Access Compliance Report

Public Rights-of-Way

(Pedestrian Signals)

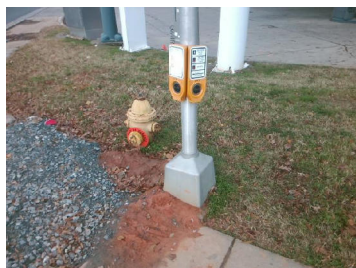
Compliance	Description	Data	Compliance	Description	Data
	Button Count	Button2	N/A	Distant to Additional Button (in)	N/A
	Additional Button Present?	No		Additional Button ID	N/A
N/A	Signal Buttons Required?	N/A	N/A	Additional Ped Posts Required	N/A
	How Many Ped Street Xings?	2		Located In An Island/Median?	No
N/A	B 1 Sign Present?	Yes	N/A	B 2 Sign Present?	Yes
Yes	B 1 Sign Purpose?	Yes	No	B 2 Sign Purpose?	No
Yes	B 1 Sign Lettering & Contrast?	Yes	No	B 2 Sign Lettering & Contrast?	No
Yes	B 1 Parallel To XWalk?	Yes	Yes	B 2 Parallel To XWalk?	Yes
Yes	B 1 PAR to Button?	No	Yes	B 2 PAR to Button?	No
No	B 1 PAR to XWalk?	Yes	No	B 2 PAR to XWalk?	Yes
Yes	B 1 Clear Floor Space?	Yes	No	B 2 Clear Floor Space?	No
N/A	B 1 FWD Approach?	No	N/A	B 2 FWD Approach?	No
N/A	B 1 FWD Approach Constrained?	N/A	N/A	B 2 FWD Approach Constrained?	N/A
N/A	B 1 FWD Approach Reach (in)	N/A	N/A	B 2 FWD Approach Reach (in)	N/A
N/A	B 1 FWD Approach Width (in)	N/A	N/A	B 2 FWD Approach Width (in)	N/A

N/A	B 1 FWD Approach Obstruction?	N/A	N/A	B 2 FWD Approach Obstruction?	N/A
N/A	B 1 FWD Approach Obstruction Dist (in)	N/A	N/A	B 2 FWD Approach ObstructionDist (in)	N/A
N/A	B 1 PARA Approach?	Yes	N/A	B 2 PARA Approach?	Yes
N/A	B 1 PARA Approach Constrained?	No	N/A	B 2 PARA Approach Constrained?	No
Yes	B 1 PARA Approach Reach (in)	9.0	Yes	B 2 PARA Approach Reach (in)	8.0
N/A	B 1 PARA Approach Width (in)	N/A	N/A	B 2 PARA Approach Width (in)	N/A
N/A	B 1 PARA Approach Obstruction?	Yes	N/A	B 2 PARA Approach Obstruction?	Yes
N/A	B 1 PARA Approach Obstruction Dist (in)	4.0	N/A	B 2 PARA Approach ObstructionDist (in)	4.0
Yes	B 1 Clear Floor Space Slope (%)	0.6	N/A	B 2 Clear Floor Space Slope (%)	N/A
Yes	B 1 Clear Floor Space XSlope (%)	1.4	N/A	B 2 Clear Floor Space XSlope (%)	N/A
N/A	B 1 PAR Slope (%)	1.5	N/A	B 2 PAR Slope (%)	1.6
Yes	B 1 Height (in)	38.0	Yes	B 2 Height (in)	38.0
Yes	B 1 Pressure (#)	3.0	Yes	B 2 Pressure (#)	2.0

Yes	B 1 Clear Xing Direction?	ClearlyMarked	Yes	B 2 Clear Xing Direction?	ClearlyMarked
	B 1 Crossing Direction	To SW		B 2 Crossing Direction	To E
Yes	B 1 DistanceTo XWalk (in)	0.0	Yes	B 2 DistanceTo XWalk (in)	0.0
No	B 1 DistanceTo Curb (in)	78.0	No	B 2 DistanceTo Curb (in)	73.0
Yes	B 1 Diameter (in)	2.0	Yes	B 2 Diameter (in)	2.0

Possible Solutions: Replace Signal Push Button With APS Button on New Post. Remove & Relocate Sign. Remove & Replace Sign.
